BULLETIN CT-01

Date: September 1st, 2022	Number: CT-1	Project #: 21162
Project Name: Piper Remodel	Attached: REV2 structural drawings (Delta 2 – Bulletin CT-1)	
Number of Pages: 17

Subject: Grade beam revisions
Main Floor framing revisions
Main Floor sheathing addition (thickness and nailing)

Drawings affected: S2.0, S2.1

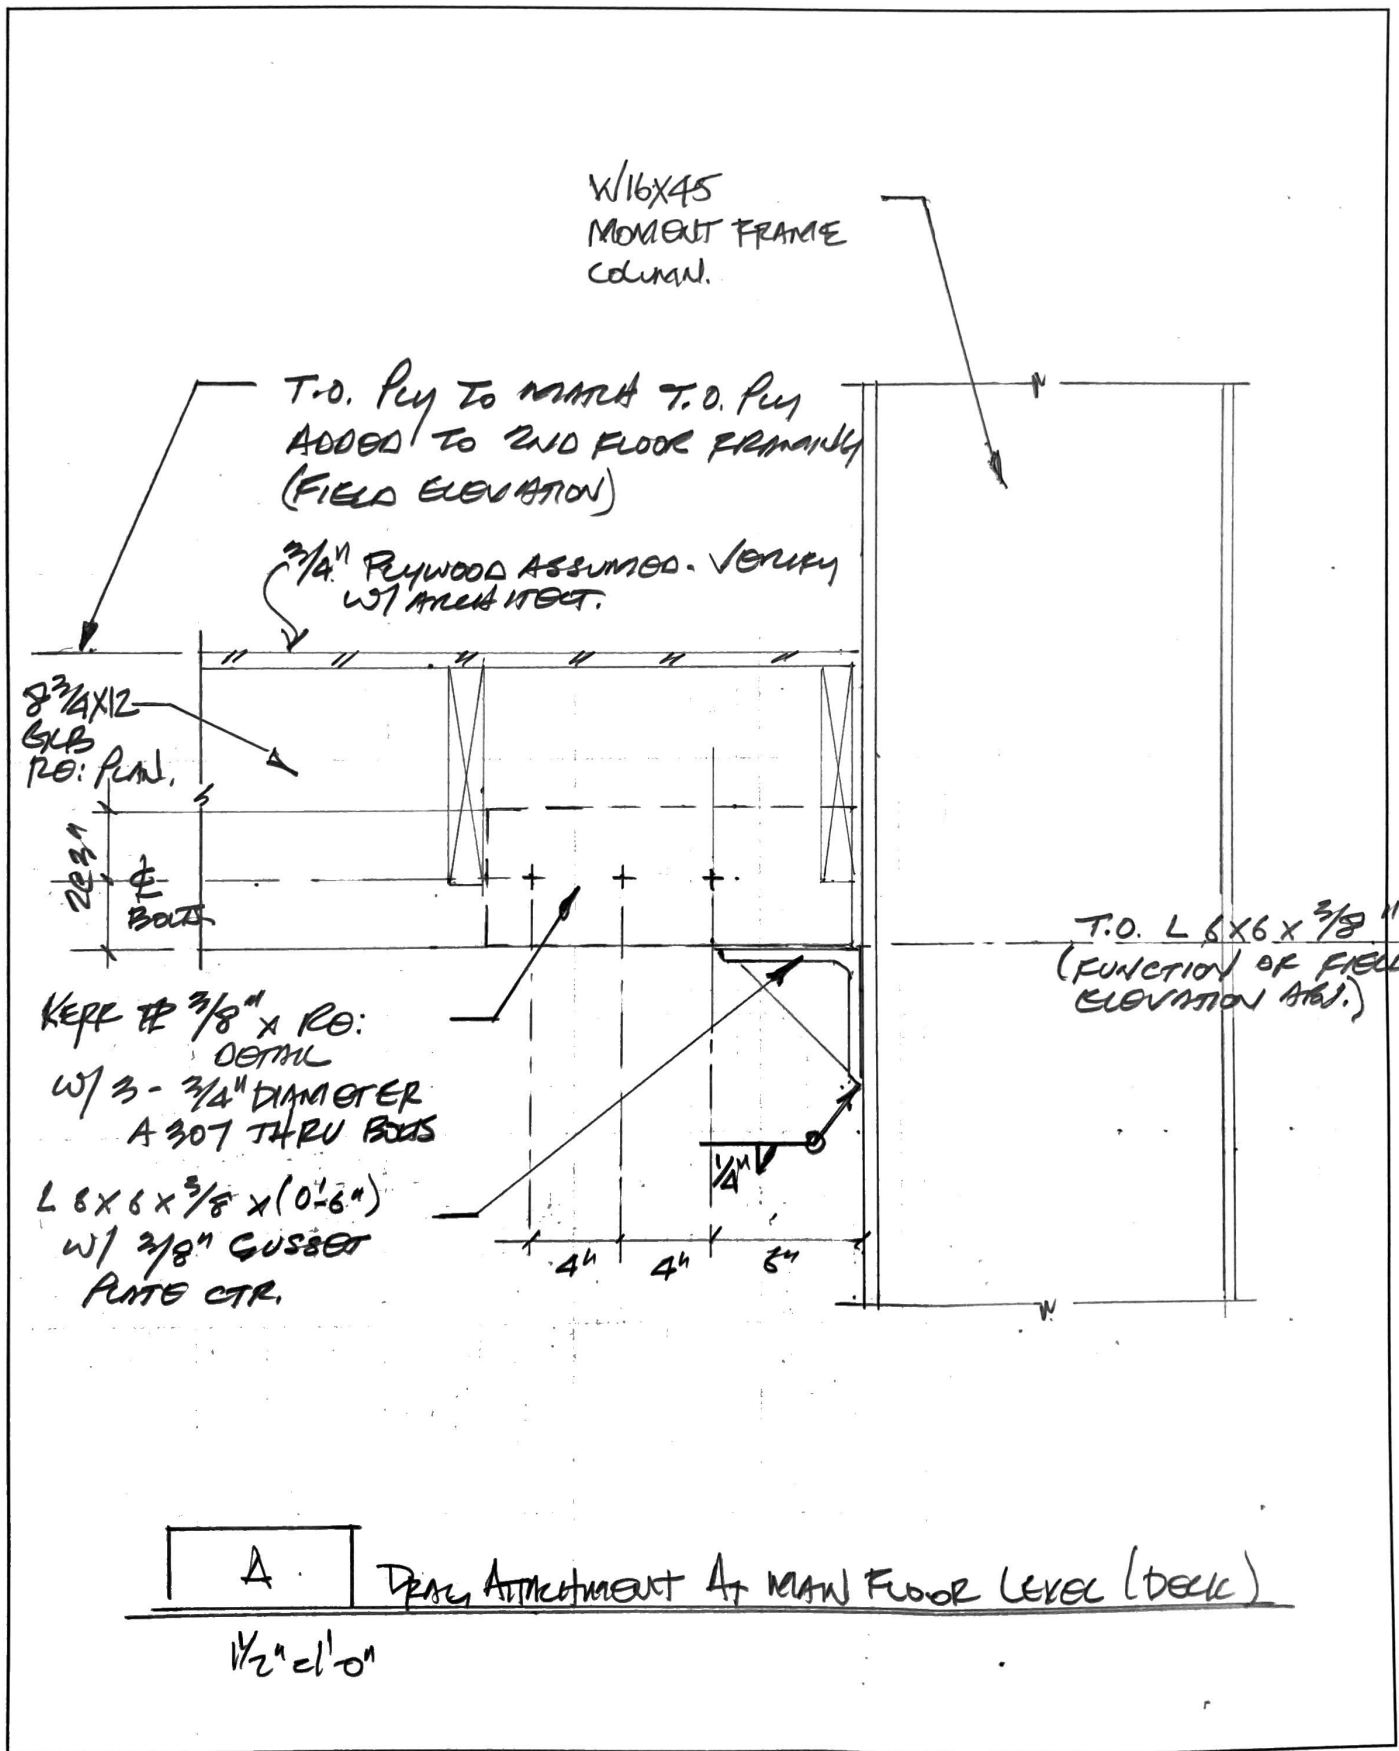
The structural drawings are silent relating to the intended drag connection to the moment frame at the main floor level (deck area), therefore we have attached sketch A, providing direction for the attachment of the 8 ¾" X 12" GLB at the south face of the moment frame W 16X45 column. Contractor will need to provide the fabricator the elevation of the top of plywood at the main floor level as this is a field dimension.

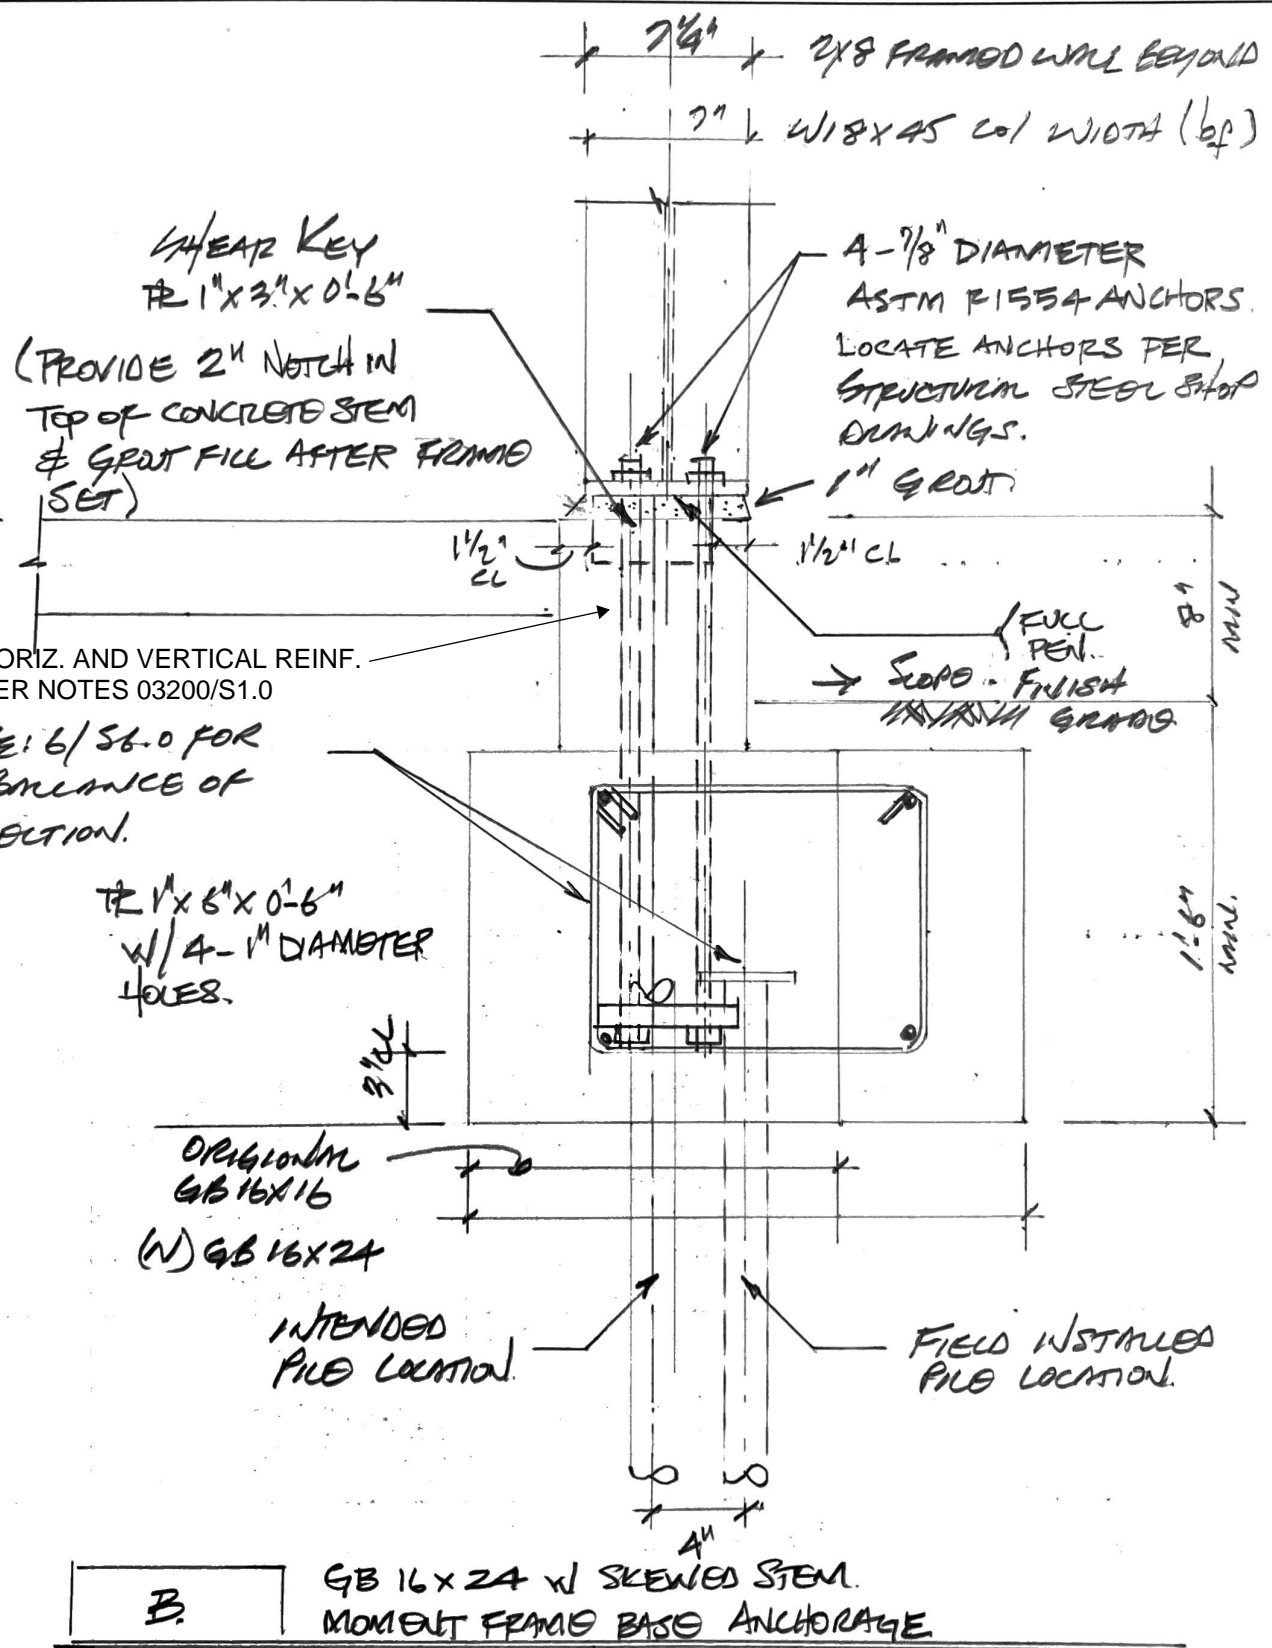
We understand that pile P17, P18 and P19 were located 4" east of the intended location. Please find attached sketch B, associated with providing a wider grade beam (GB16X24) in lieu of a GB 16X16 per plan. It is structurally acceptable to use the same shear reinforcement and top and bottom steel for the smaller GB16X16, centering the shear steel in the wider grade beam. Sketch B also clarifies the anchorage requirements for the moment frame.

Partial
Main Floor Framing Over Basement Level Shear Walls

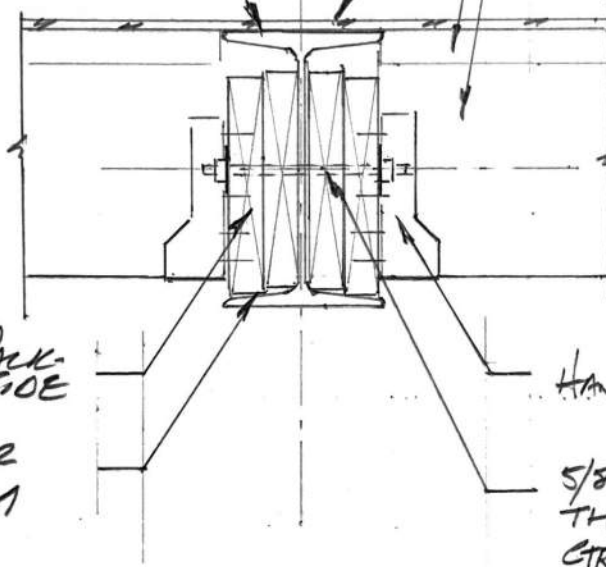
We have coordinated some additional framing variances with Donovan with Weaver Construction and have summarized these items in the attached partial S2.1 main floor framing plan. Additionally, we have included revised header and landing framing at the new east stairs. Please reference the attached partial framing plan red-markups attached.

(E) JOIST AT (E) UPSET STEEL BEAM.

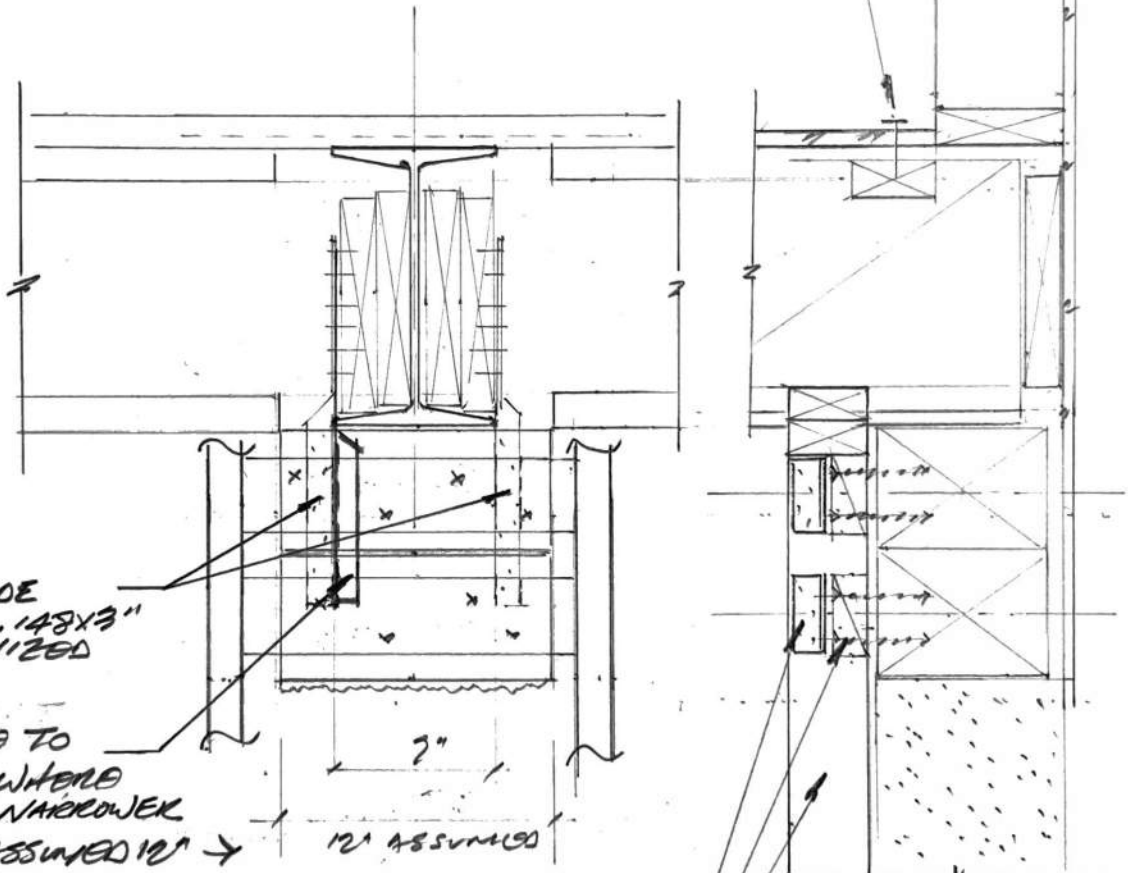
(E) STEEL IBM
UPSET INTO
FLOOR FRAMING,
LOCALLY DEMO
2X LAMBER DIA.
PIRAGMA. CUT BACK
JOIST.

(N) 2-2X PLY-
OUT EACH SIDE
2X^S TO BEAR
AND BOTTOM
FLANGE.

5/8" DIAMETER A36
THREADED ROD AT 32" O.C.
CTR. W/ STANDARD WASHERS.
(A307 TRU BOLTS OK
ALTERNATE)

- IT IS STRUCTURALLY ACCEPTABLE TO PROVIDE HANGERS AT 2X8^S & 4X10^S PER NOTES 06300/S1.0. HANGERS DO NOT NEED TO BE SIZED FOR 3-2X WIDTH OR 4X+2-2X WIDTH, BUT CAN BE SIZED TO SUPPORT EXISTING CENTRAL MEMBER CONSISTING OF 2X8 OR 4X10. ADDED SYSTEMED MEMBERS INCREASE STIFFNESS OF FLOOR SYSTEM BUT ARE NOT REQUIRED TO SET IN HANGERS.

(E) UPSET STEEL BEAM AT EXTERIOR WALL
(MAIN LEVEL)

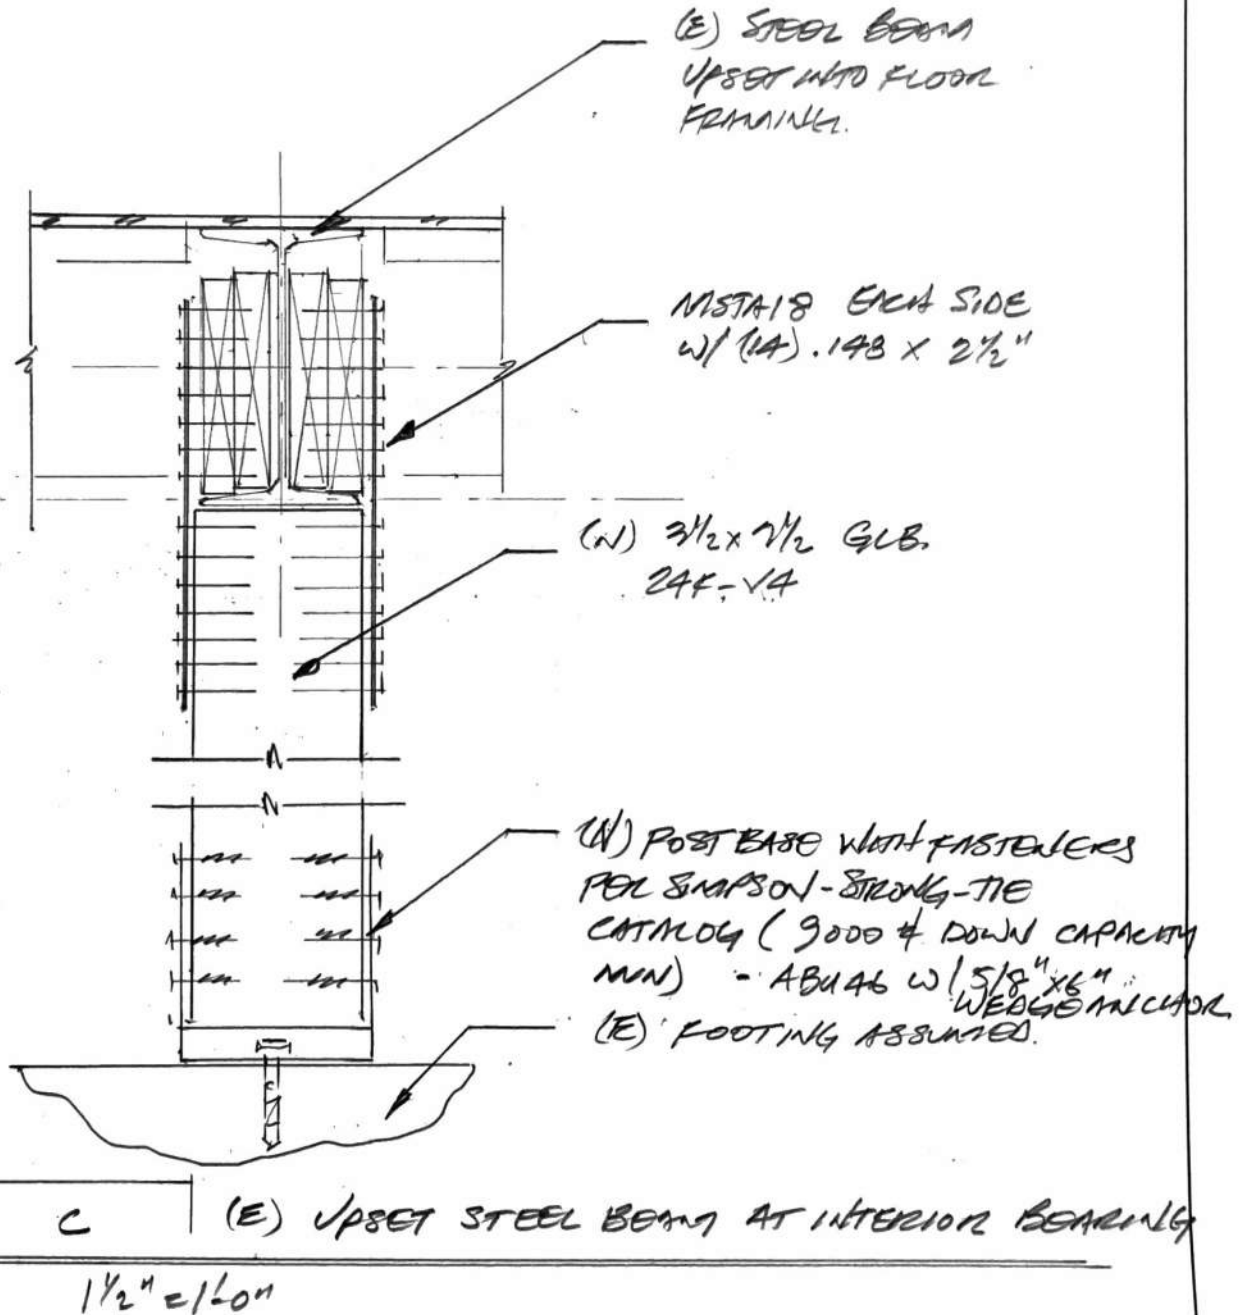
ANCHOR P.T. 6X8³ (OR 12X8)
W/ FLAT 2X4 BLOCKING
W/ 4 - S0S25³⁰⁰ EACH BACK TO PT. MEMBERS
W/ 1 - A35 EACH END W/ 12 - #9X1 1/2" SD CONNECTOR
SCREEN.

E 3/59.0 ALTERNATE - MULTI PLY RATHER OR JOIST ATTACHMENT.
 1 1/2" cl-0"

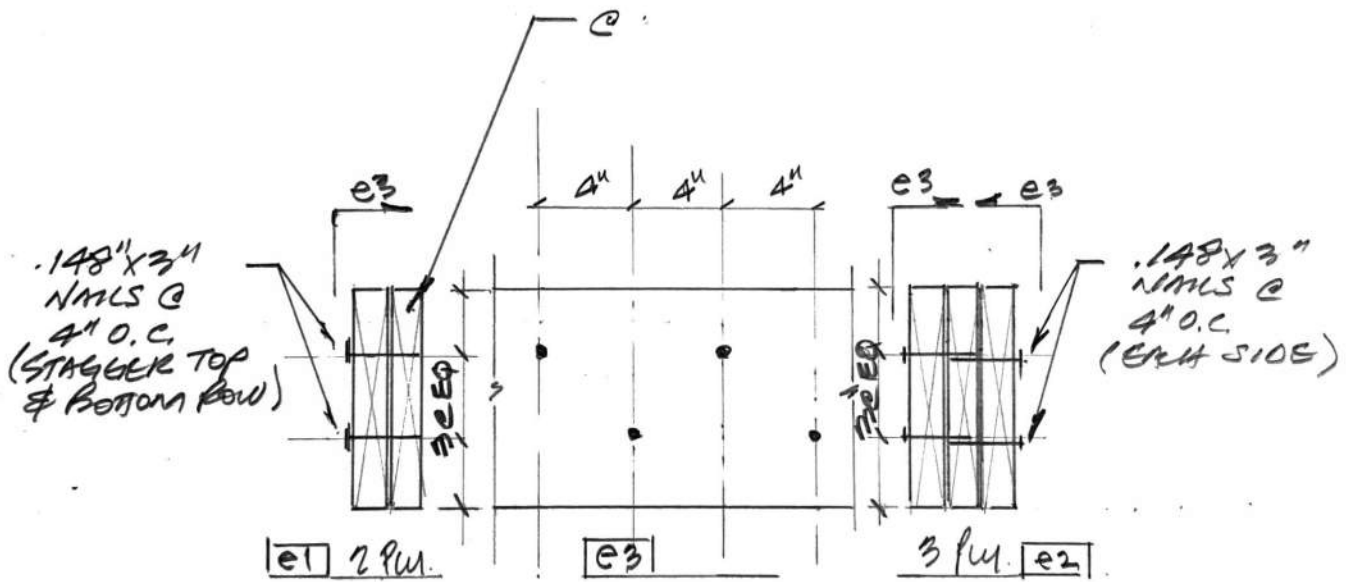
We have approved a contractor variation request associated with the stitching attachment of multi-ply joist. Sketch E attached provides direction associated with this variance and can be used in tandem or in lieu of 3/S9.0.

#4406 WEAVER CONSTRUCTION
 PIPER RESIDENCE
 STEEL QUESTIONS

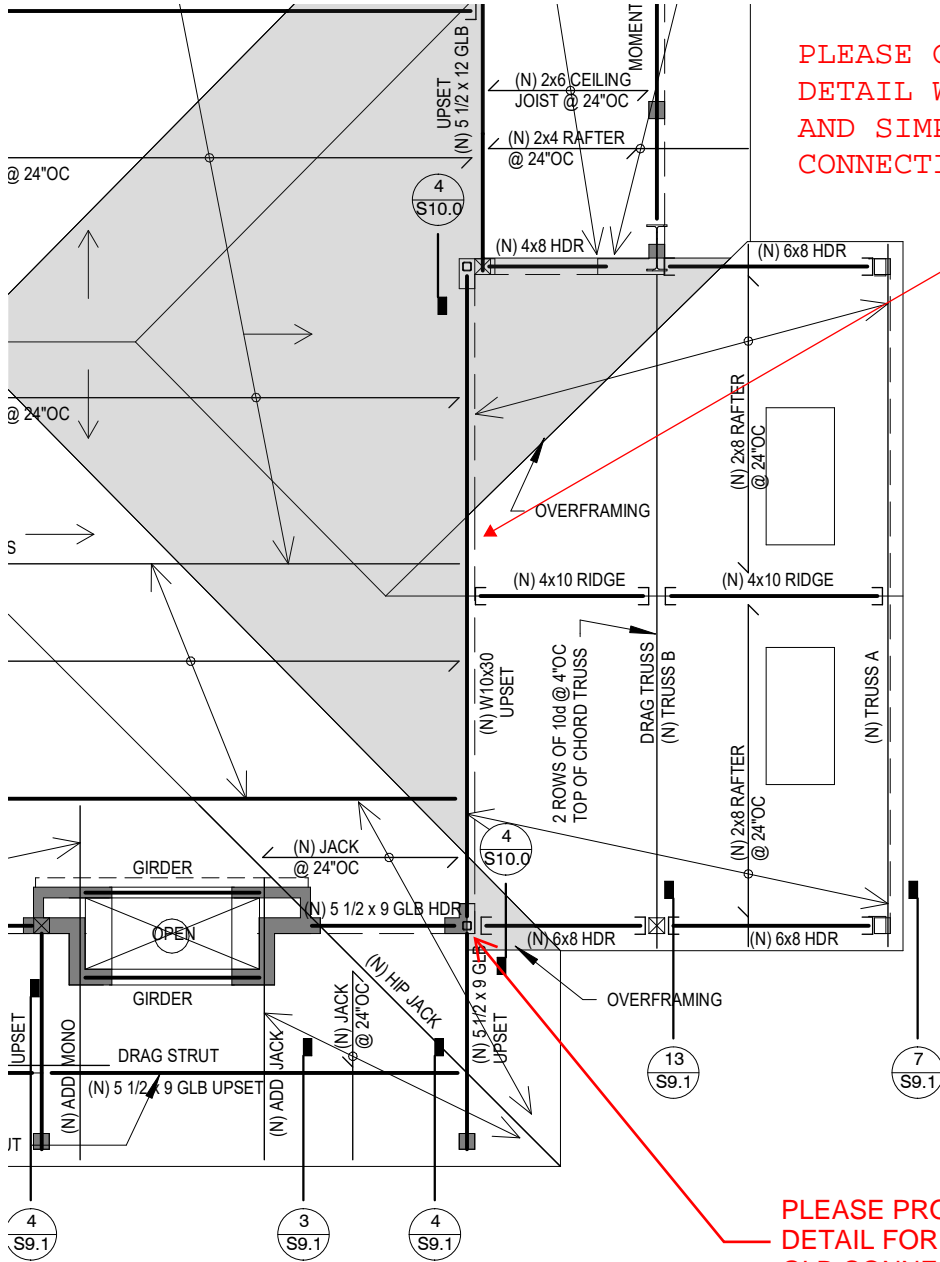
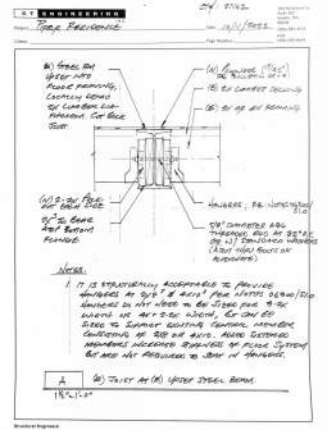
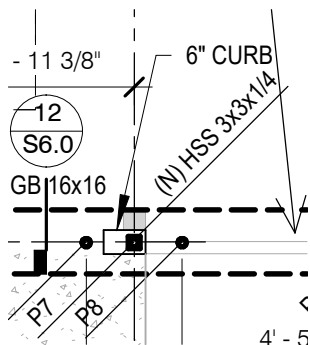
PLEASE CONFIRM DETAIL BELOW
 DETAIL WILL WORK FOR FIRING
 AND SIMPSON BRACKET BRACKET
 CONNECTION

PLEASE PROVIDE
 DETAIL FOR W10X30
 TO
 GLB CONNECTION

NO DETAIL PROVIDED FOR BASEPLATE OF
 HSS 3X3X1/4" COLUMNS. PLEASE SUPPLY

We understand that additional information has been requested associated with the roof level W10x30 and HSS 3 supporting columns at the north and south bearing ends. Attached sketches provide additional structural direction sufficient for structural steel shop drawings development. Additional refinement of these details is expected during our shop drawing review and we have the opportunity to respond to additional comments / questions.
